PLAN OF PROPOSED IMPROVEMENT

NINTH ADDITION TO BLACKHAWK SUBDIVISION - PLAT AND REZONE

CITY PROJECT NO. 11943

PLAN AND PROFILE
BLACKHAWK RD SIDEWALK CITY OF MADISON

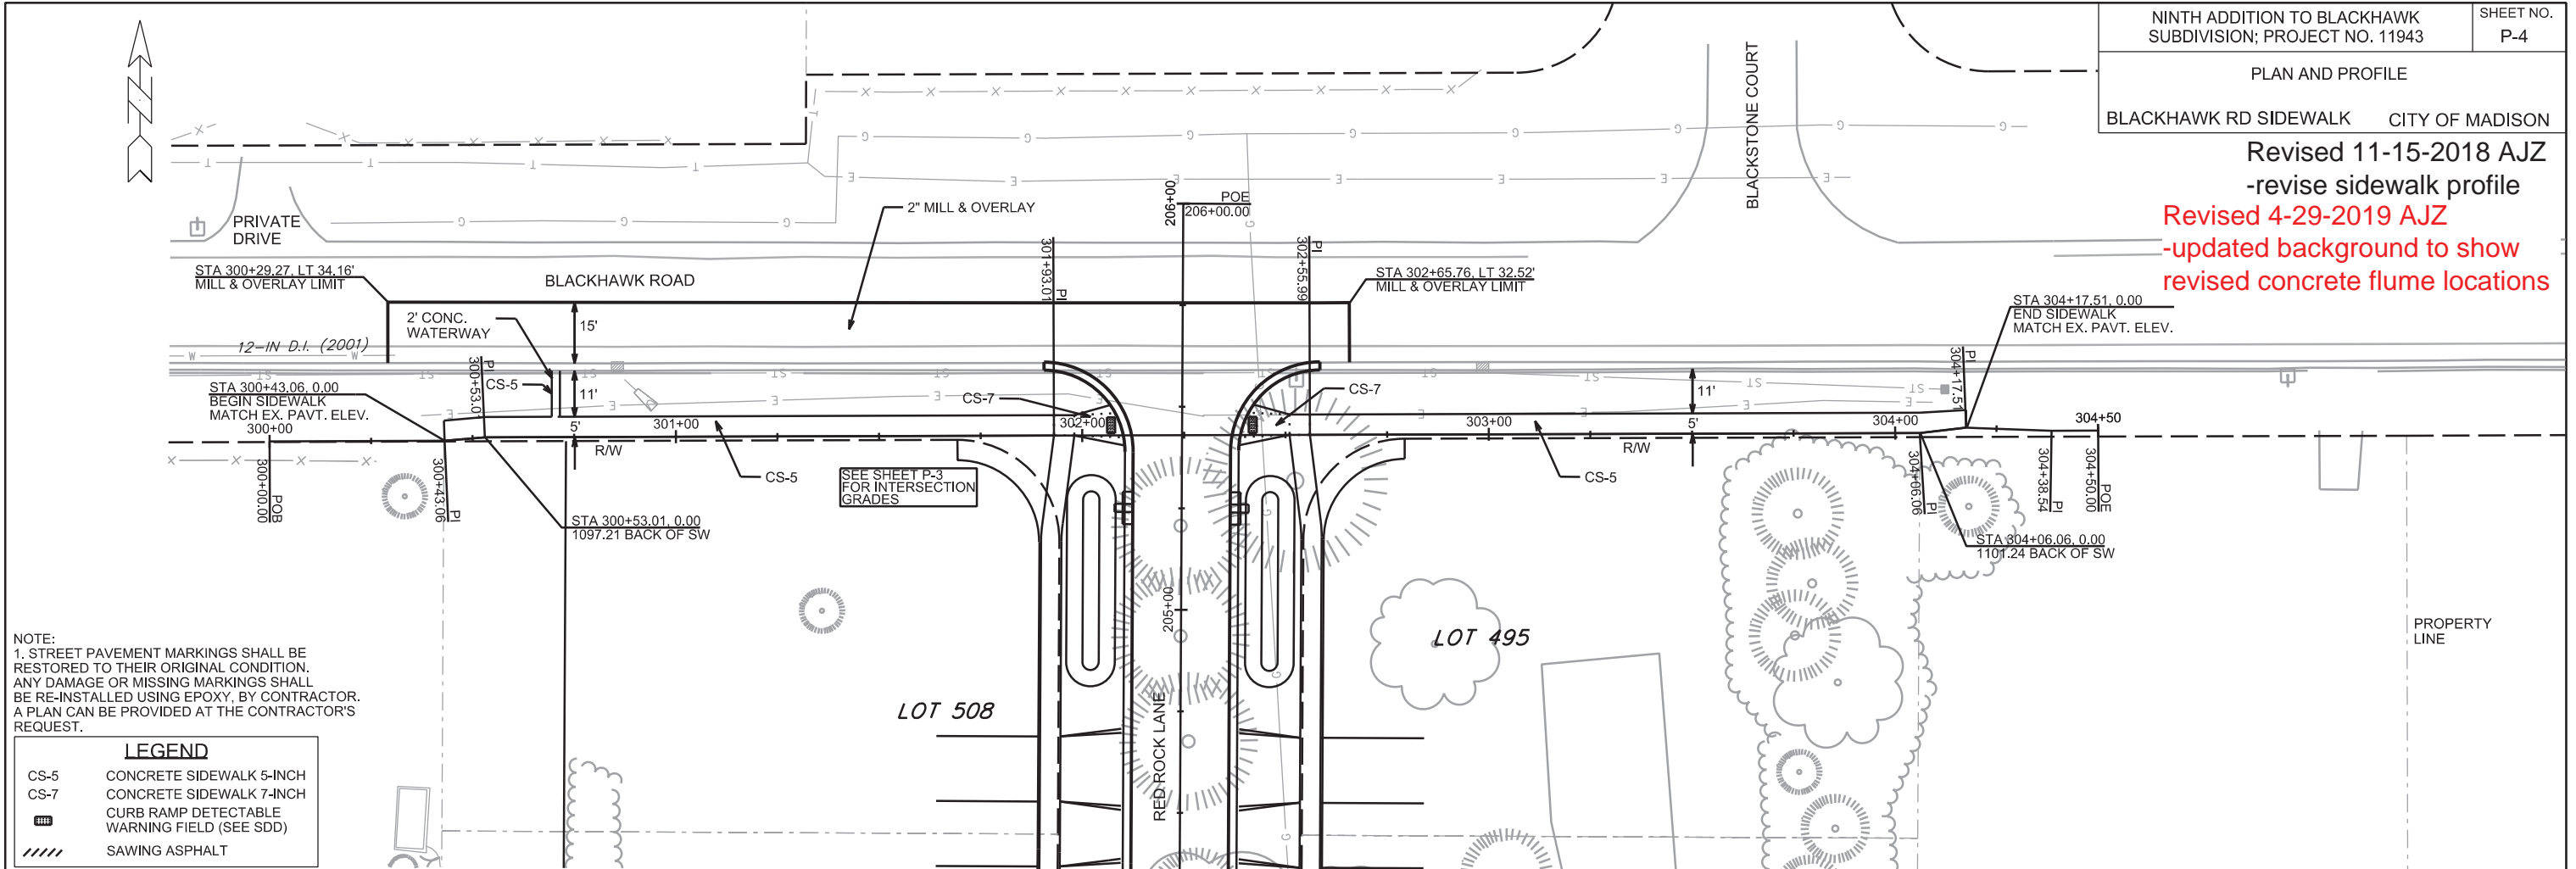
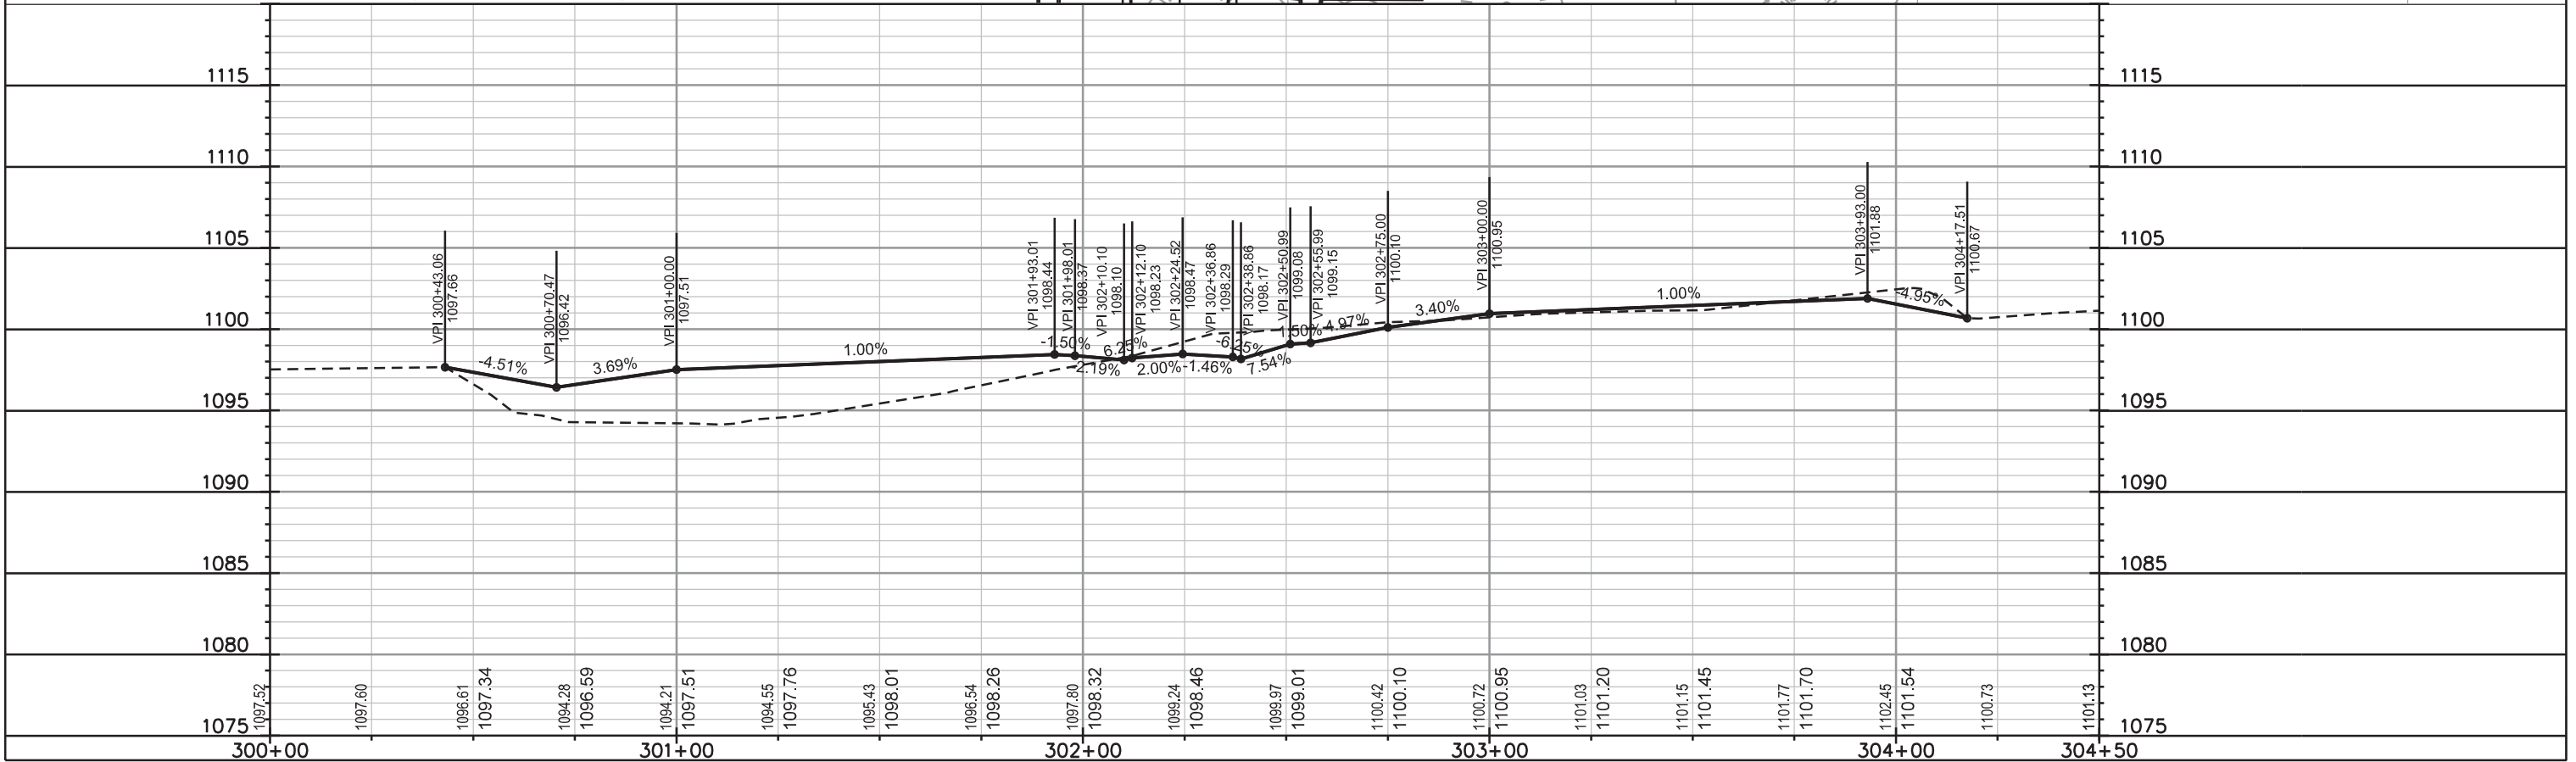
Revised 11-15-2018 AJZ
-revise sidewalk profile
Revised 4-29-2019 AJZ
-updated background to show revised concrete flume locations

UTILITIES PLAN AND PROFILE

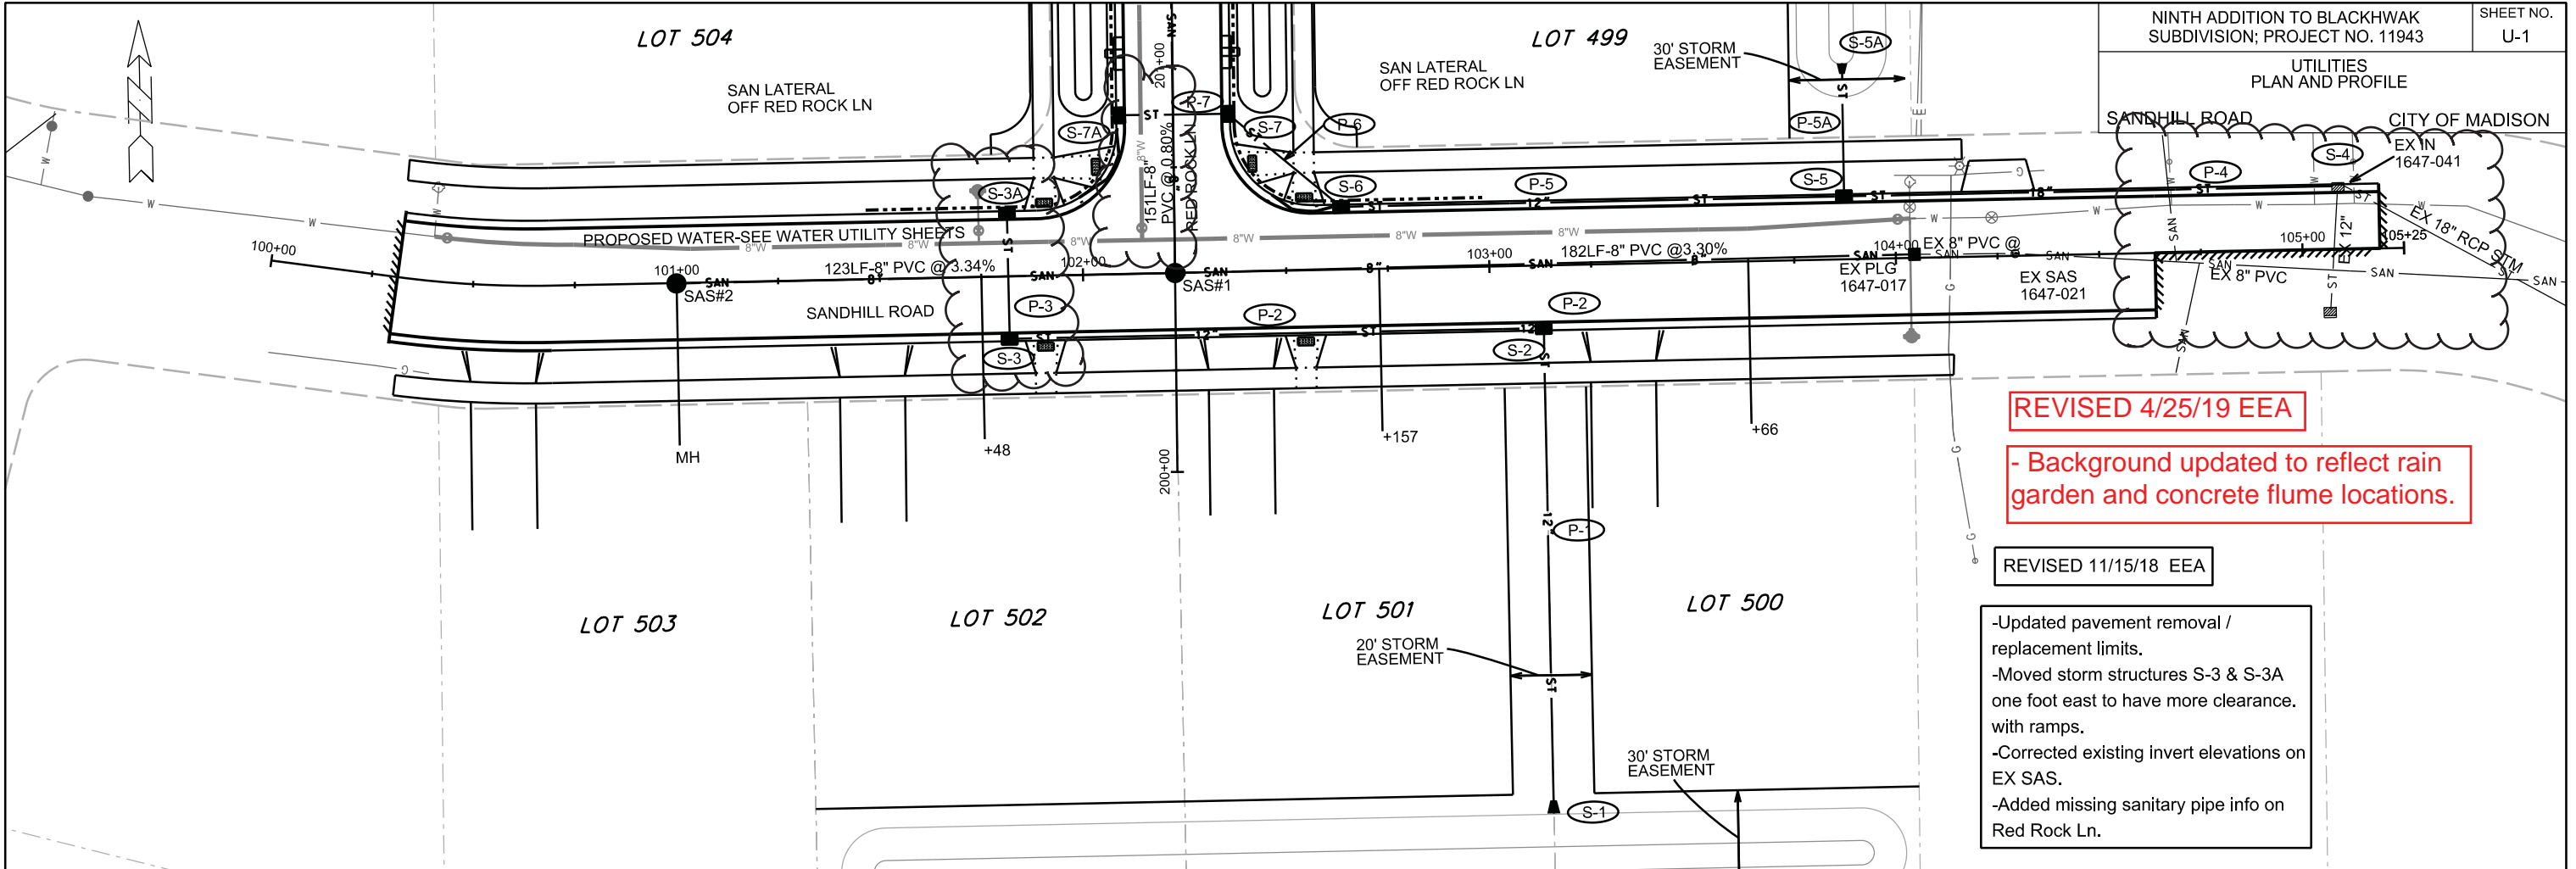
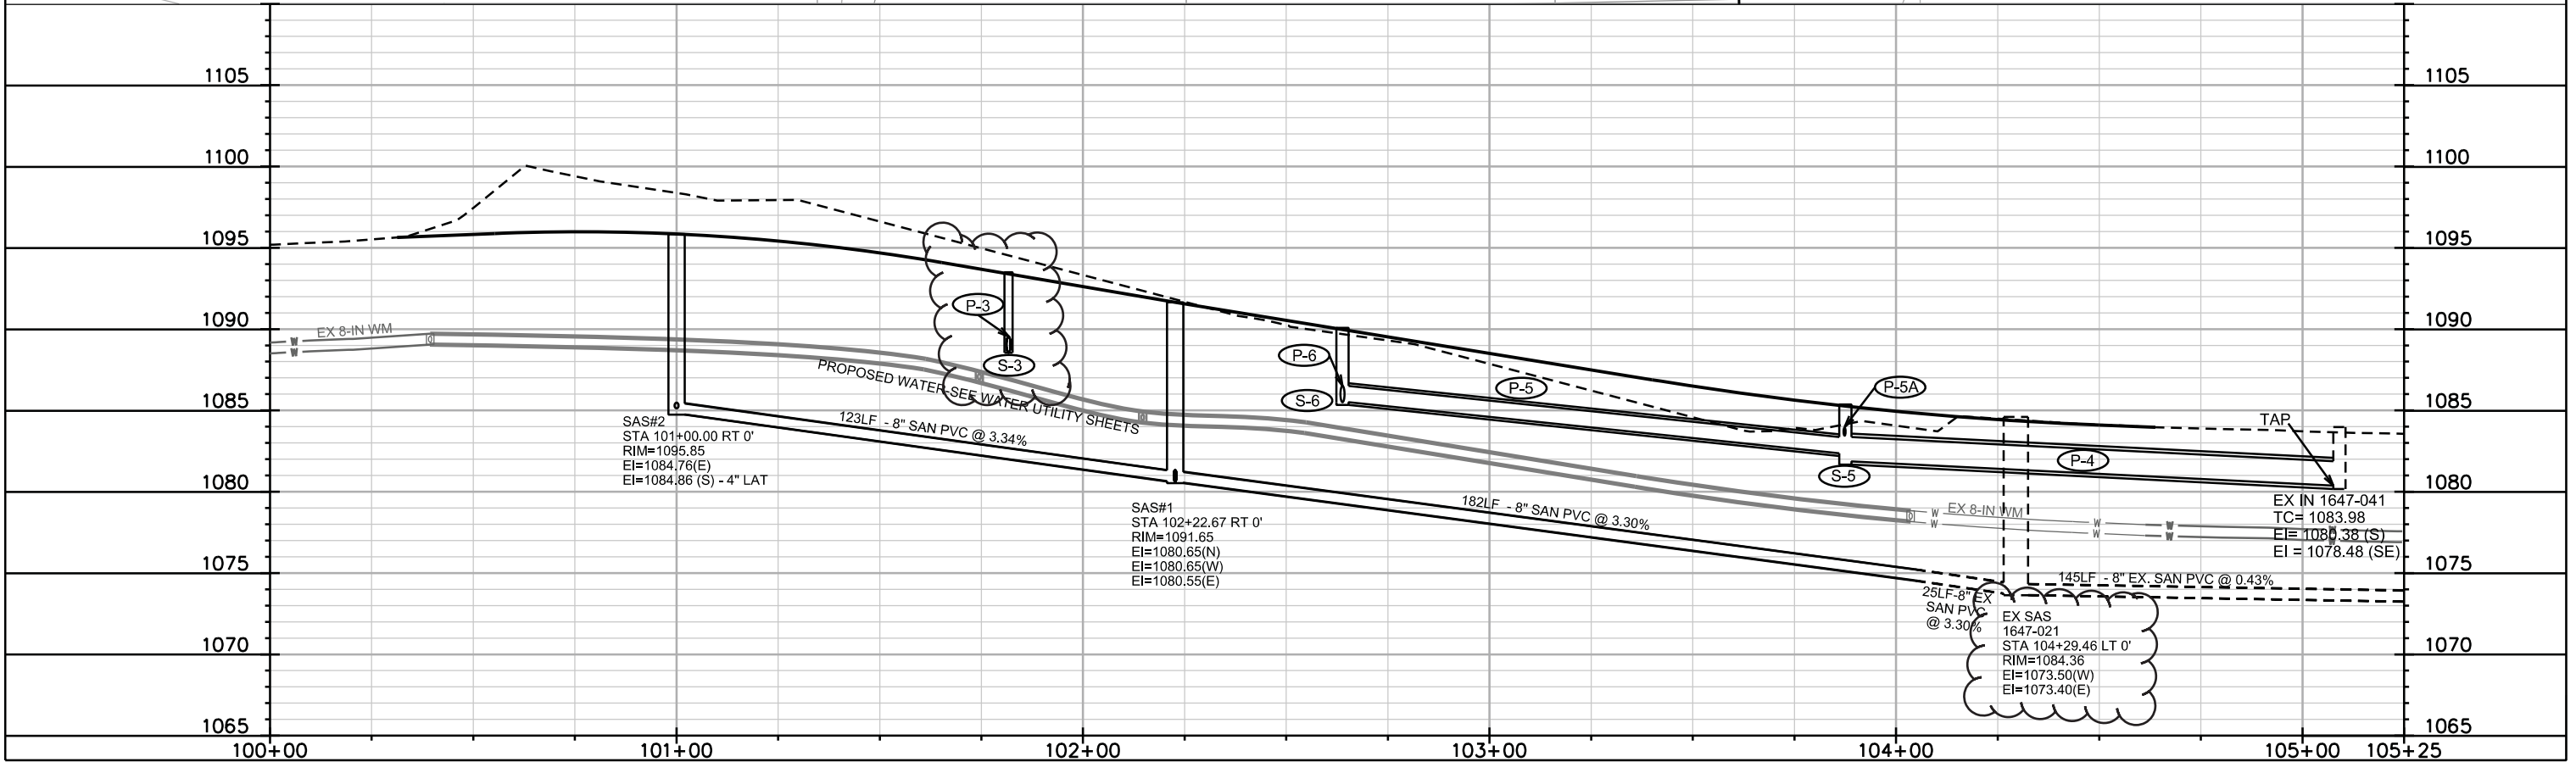
REVISED 4/25/19 EEA
 - Background updated to reflect rain garden and concrete flume locations.

REVISED 11/15/18 EEA
 -Updated pavement removal / replacement limits.
 -Moved storm structures S-3 & S-3A one foot east to have more clearance with ramps.
 -Corrected existing invert elevations on EX SAS.
 -Added missing sanitary pipe info on Red Rock Ln.
